UNITED STATES
NUCLEAR REGULATORY COMMISSION
DOCKET NO. 50-324
LICENSE NO. DPR-62

LICENSING SUPPORT INFORMATION
FOR
PROPOSED CHANGES TO TECHNICAL SPECIFICATION
PRESSURE SWITCH TO ANALOG REPLACEMENT

BRUNSWICK STEAM ELECTRIC PLANT
UNIT NO. 2

OCTOBER 12, 1979

FIGURE 7-1

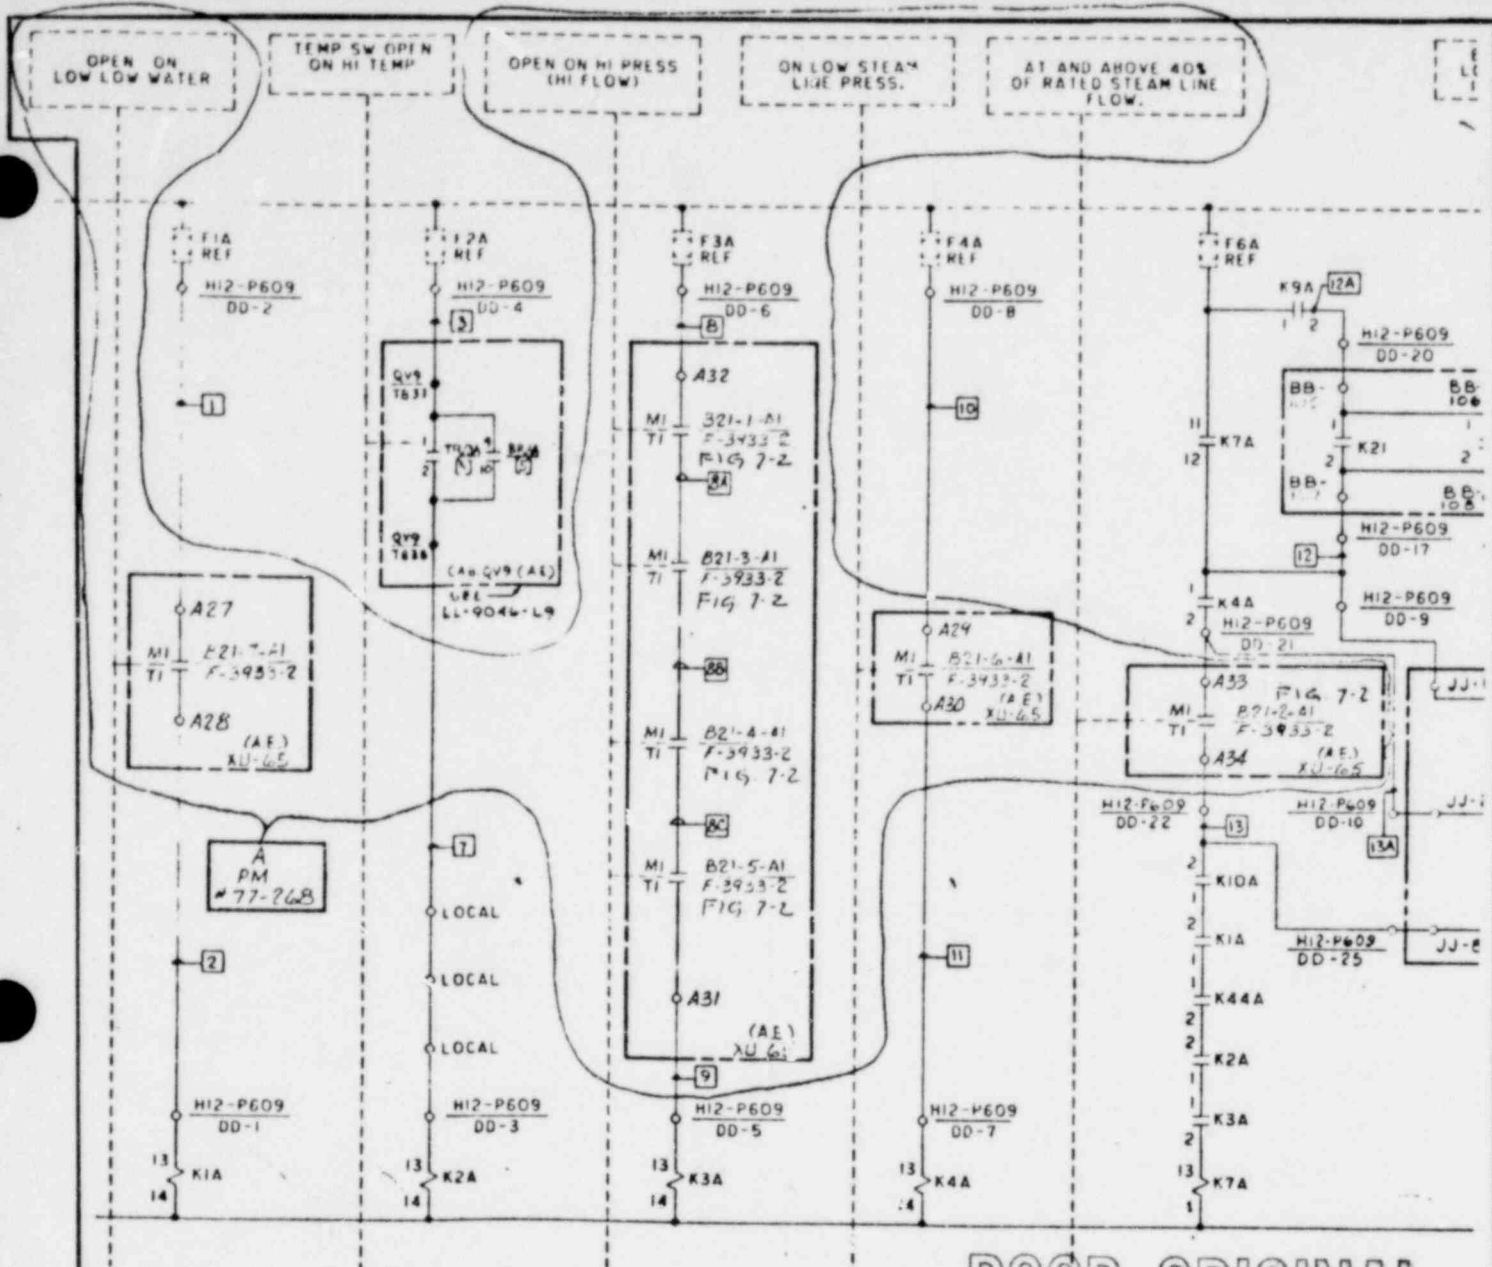
Refer to Figures 7-1, 7-2 and 7-3 which show changes introduced to the logic input circuit for specific loops B21-N006A, 7A, 8A and 9A.
